FORMAL ADA/PROWAG CIVIL RIGHTS GRIEVANCE

City of Bloomington, Indiana

East Second Street Pedestrian Access Barrier — Rogers-Binford Elementary School Corridor

Re: ADA / PROWAG Non-Compliance — Inaccessible Pedestrian Route, East Second Street between Eagleson Drive and High Street; No Accessible Route to Rogers-Binford Elementary School

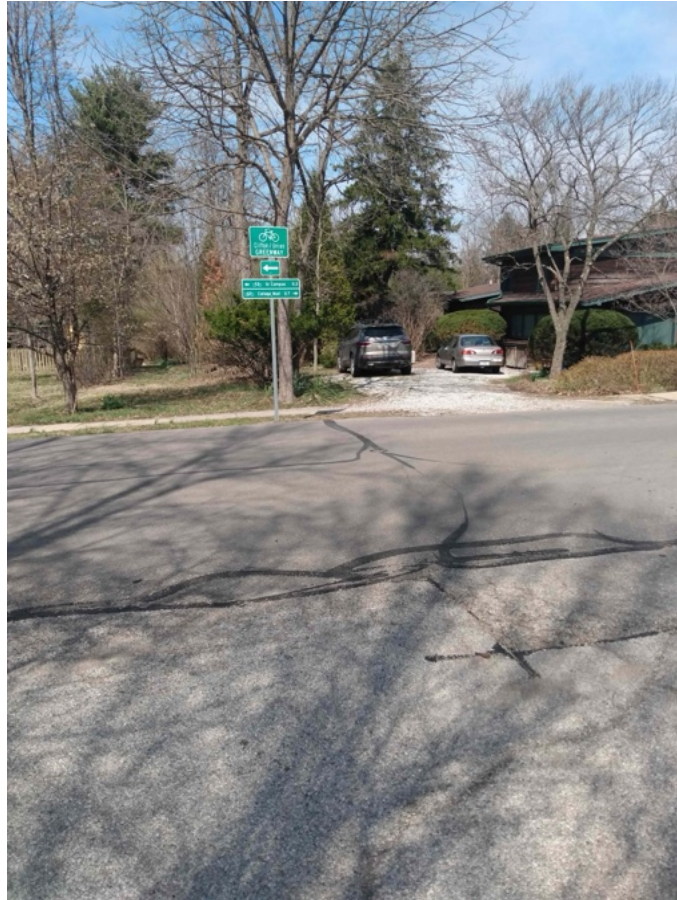
The City has not neglected this location entirely. As documented in Fig. 2 below, the City has installed official bicycle wayfinding signage at this exact location, designating it as part of the "Clifton / Union Greenway." The sign provides distance markers to IU Campus (0.3 miles) and College Mall (0.7 miles), confirming that the City considers this location part of its active transportation network.

- **Demonstrates awareness:** The City knew this location well enough to designate it as part of a named greenway network. It cannot credibly claim ignorance of the gap.
- **Undermines 'undue burden' defense:** The City had resources to plan, design, fabricate, and install greenway wayfinding signage at this exact location. The claim that constructing a sidewalk segment would constitute an undue financial burden is difficult to reconcile with the investment already made in bicycle infrastructure here.
- **Establishes unequal service:** The City actively provides and promotes transportation infrastructure for cyclists at this location while denying equivalent infrastructure for pedestrians with disabilities. This contrast implicates 28 C.F.R. § 35.130(b)(1)(ii) (unequal service) and 28 C.F.R. § 35.130(b)(4) (methods of administration that have a discriminatory effect).

- **Establishes this as a City project, not an oversight:** The greenway sign identifies this location as part of a named City corridor project. The failure to provide an accessible pedestrian route is not an isolated oversight but a deliberate investment decision that excluded accessibility.
